PARTS BULLETIN

No: 6-20

Subject: Washer Removed 01230, 11477 & 11940 Kits

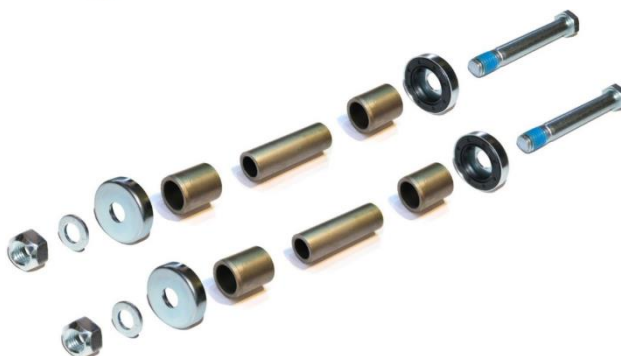
Tine assembly side arms use M12 bolts in #01230 Bolt sets. These bolts are now slightly shorter than those used in previous tine assemblies.

This means only one #09031 M12 washer is now required in Bolt set #01230 and the following kits have had the washer near the bolt head removed to reflect this:

Please note the RRP for these kits remains the same. Existing Sales Orders for these kits may have been sent with the extra #09031 washer which can be discarded.
